ADDENDUM No. 3 – February 3, 2022

This addendum modifies, amends, and supplements designated parts of the Contract Documents for the above project and is hereby made part thereof by reference and shall be as binding as though inserted in locations designated hereunder.

ARCHITECT: LPA|A LAMOUREUX PAGANO ASSOCIATES | ARCHITECTS lpaa.com	PROJECT TITLE: Doherty Memorial High School 299 Highland Street, Worcester, MA 01602	REFERENCE: A4.10 DRAWING TITLE: Multi-Media Maker Space Ceiling Grid	DATE: 02/03/22 DRAWING NUMBER: ADD-3 A-029

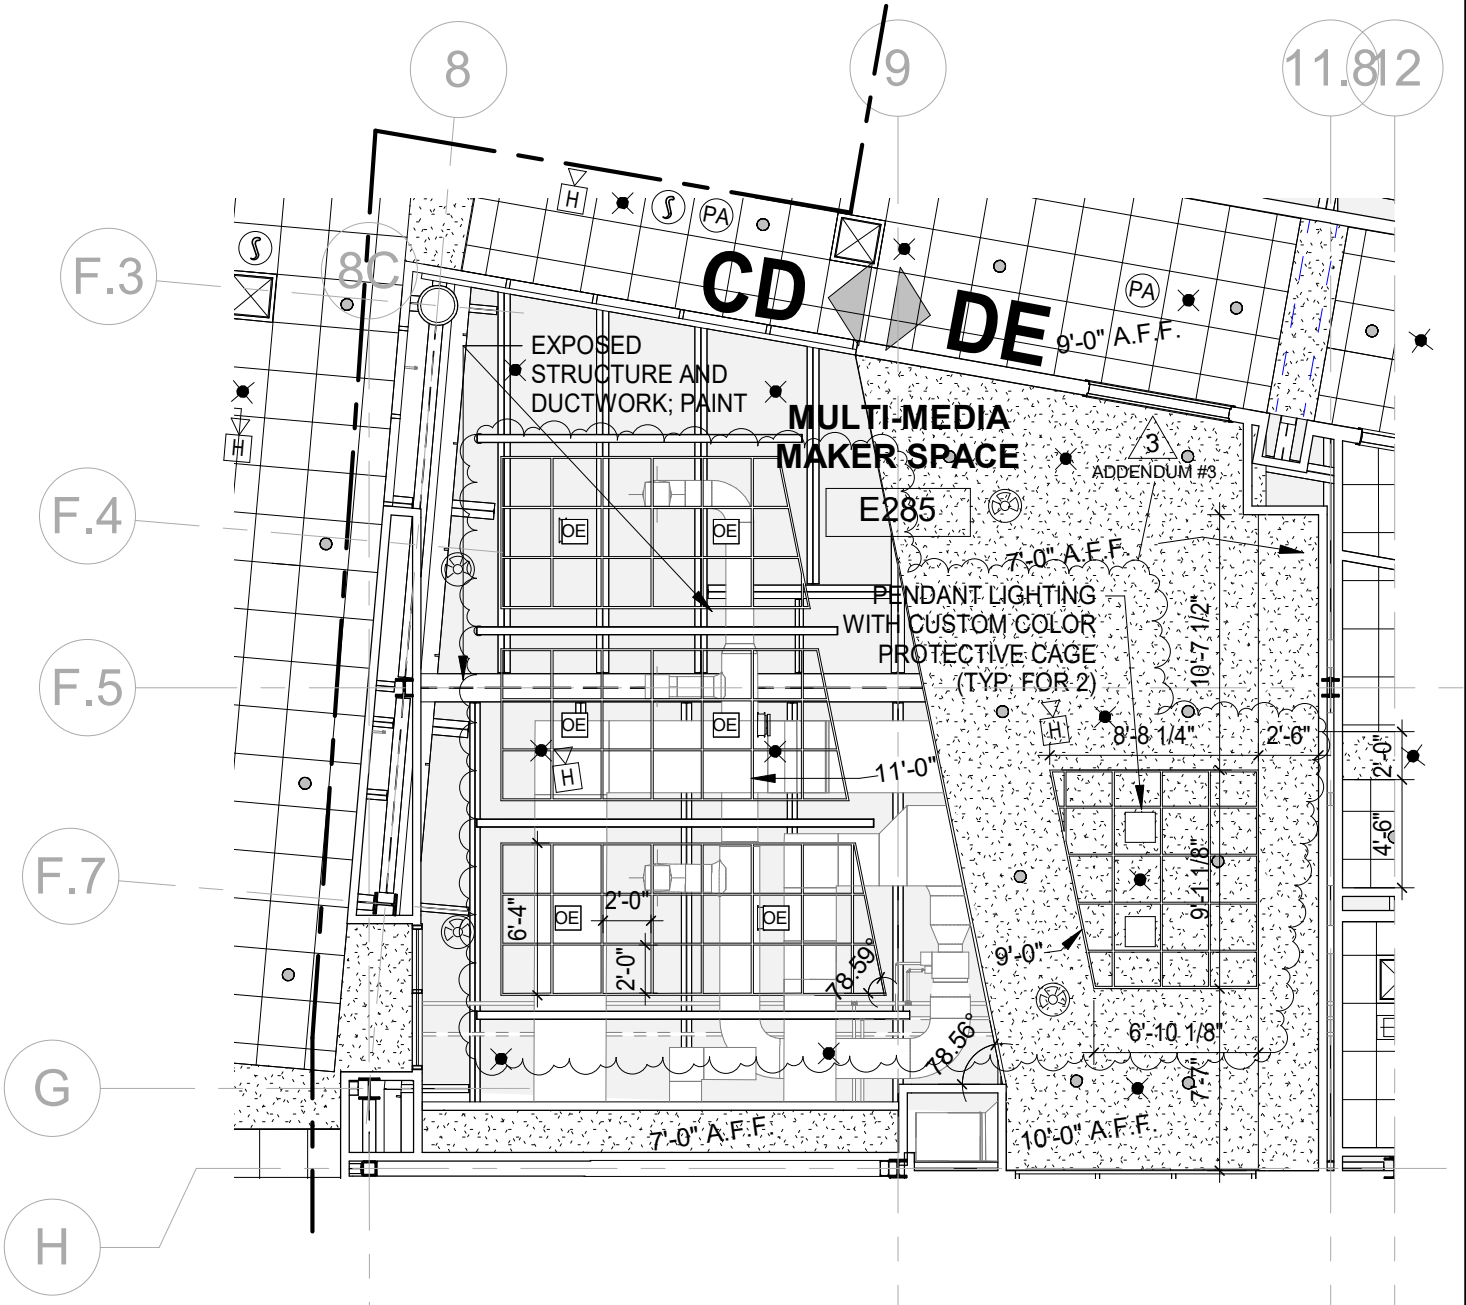
A. In Multi-Media Makers Space (E285) update ACT-9 grid to a 24" x 24" grid spacing.
1. Refer to Sketch ADD-3 / A-029 for item A above.
